Bottom Side

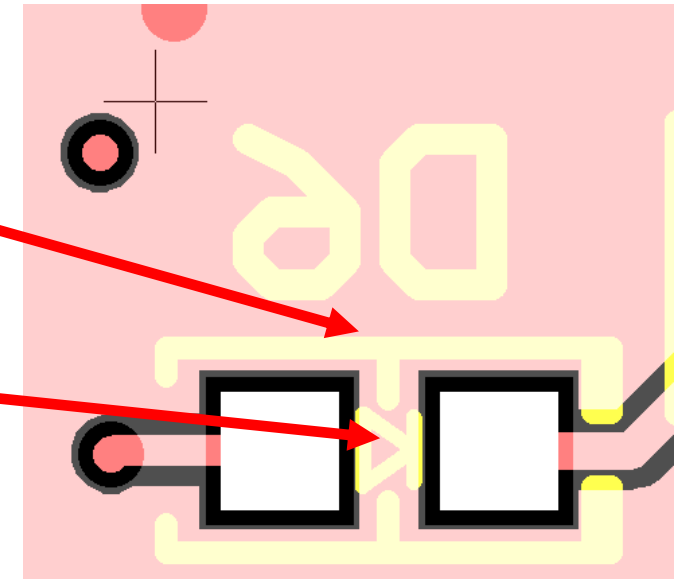
Move the polarity indicator to outside of the component footprint. Allows for verification post placement.

To Here

From here

Bottom Side

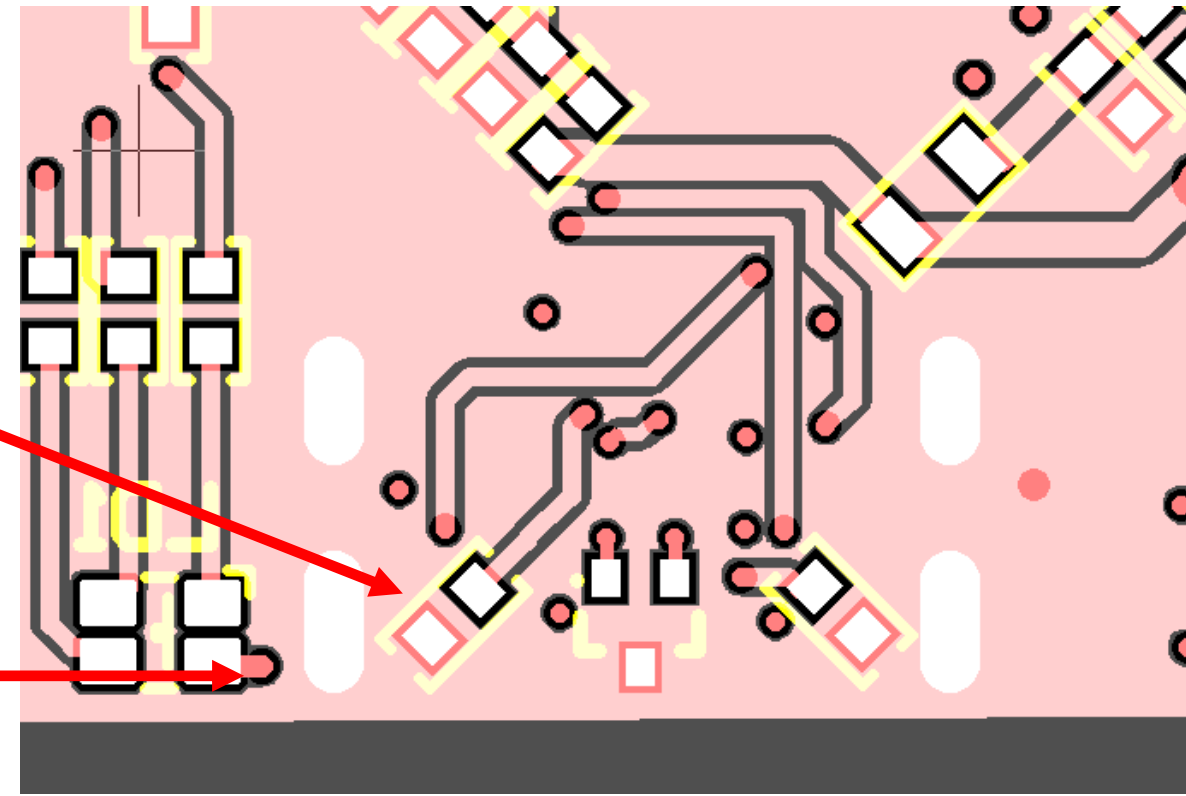
Move SMT parts away from the THT pads, potential interference with Selective solder. There are several locations, samples shown here.
Prefer .25" clearance, if possible, otherwise please provide as much clearance as the design will allow.

Top Side

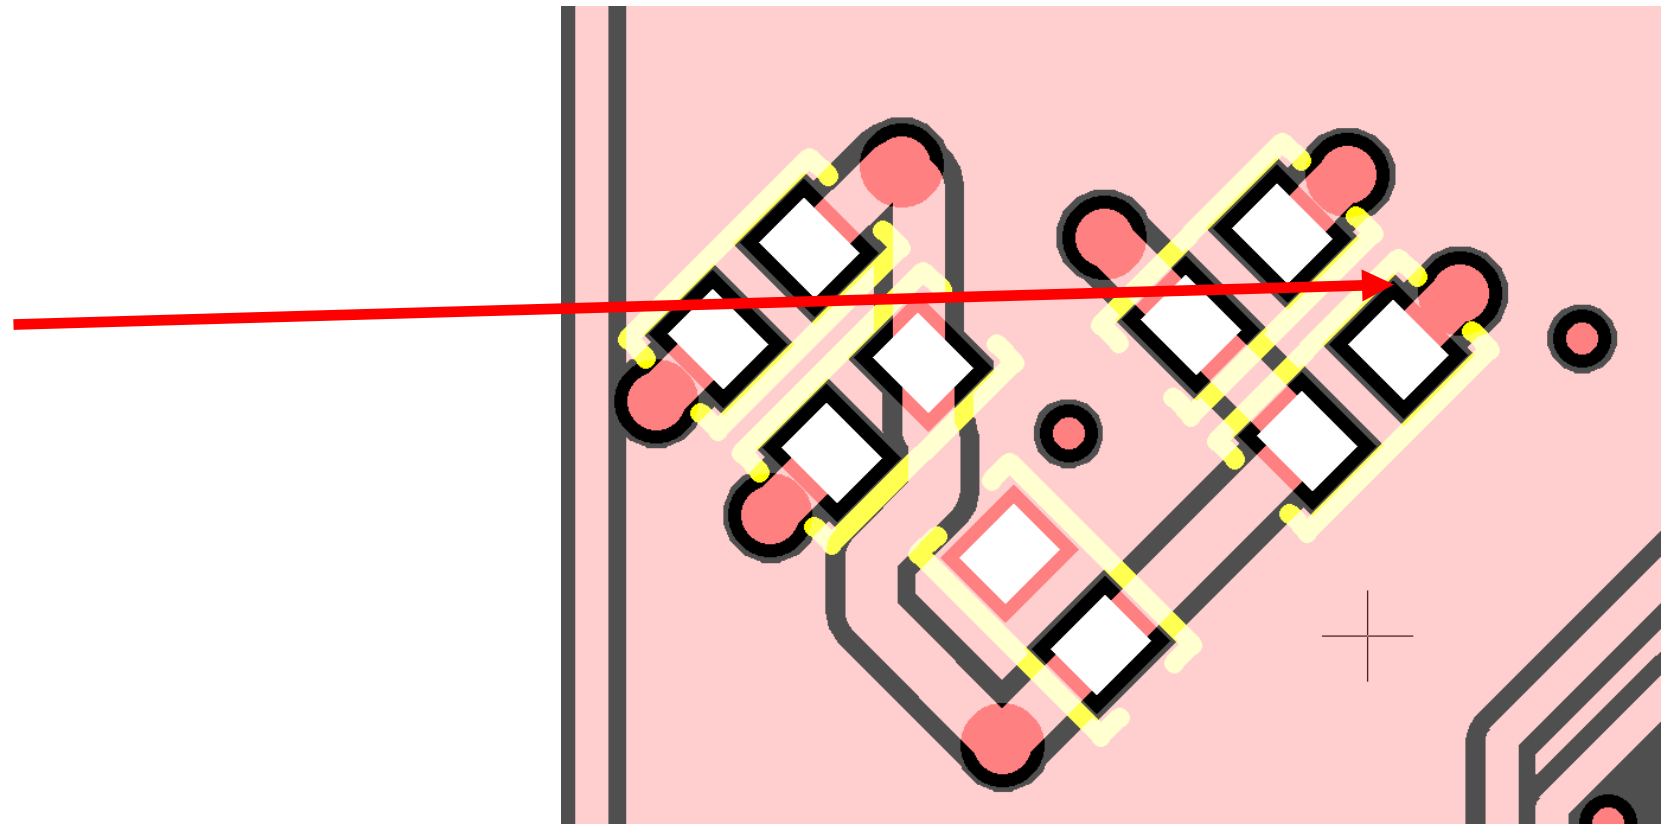
Fab drawing says to fill and cap vias that are in SMT pads, however some vias are pad adjacent with little or no SM web. Its unclear if these vias will be tented, if so no issue. Otherwise ask to tent vias or fill and cap all vias.

There are many instances of thermal relief issues, only a few examples shown here.

Adding thermals to balance the CU on passive components is recommended to help prevent tombstones.

Top Side

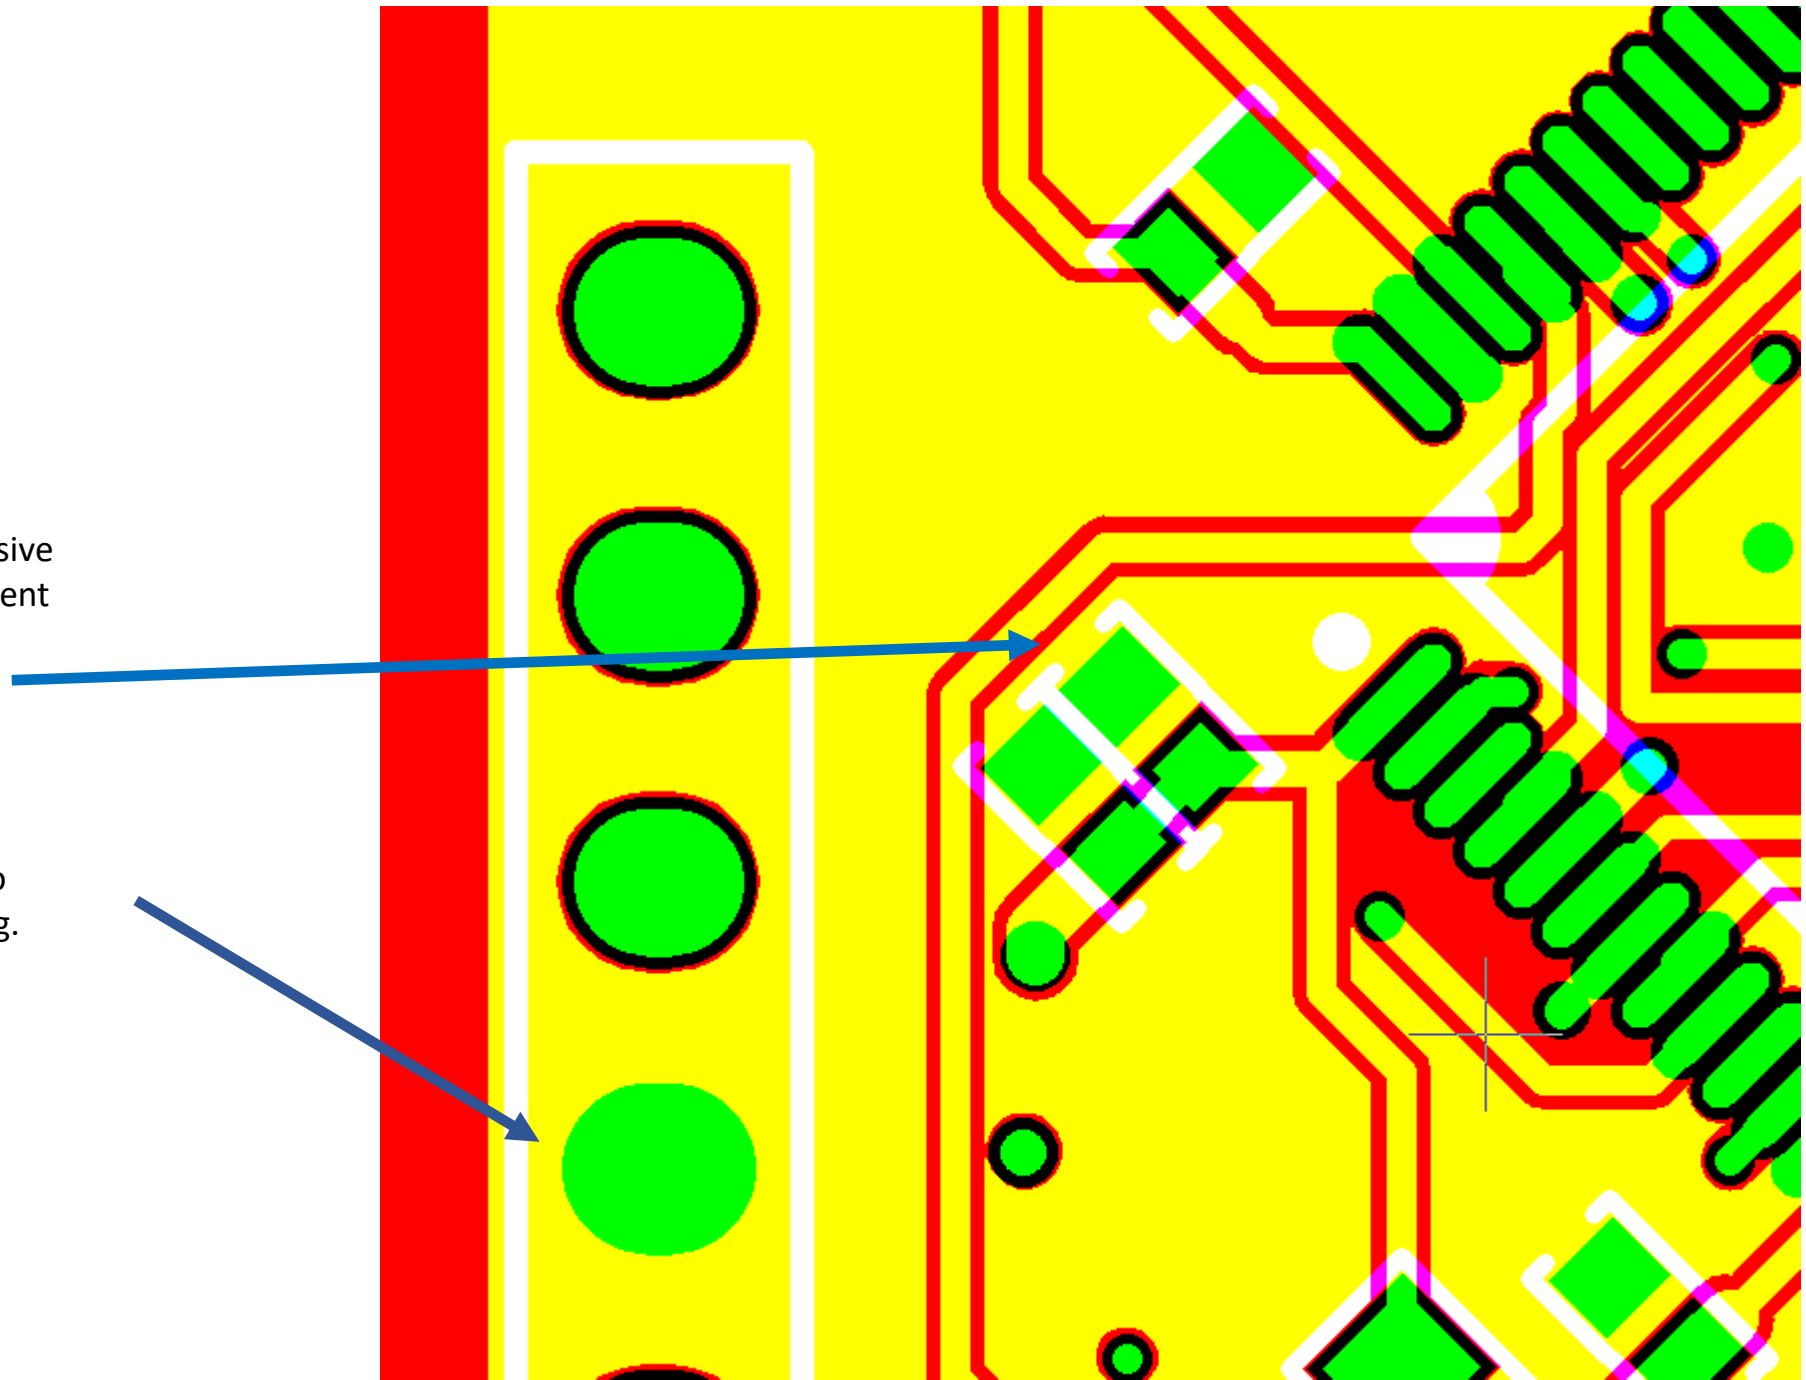
Add thermal relief wherever possible to promote equalized reflow and soldering.

There are many instances of thermal relief issues, only a few examples shown here.
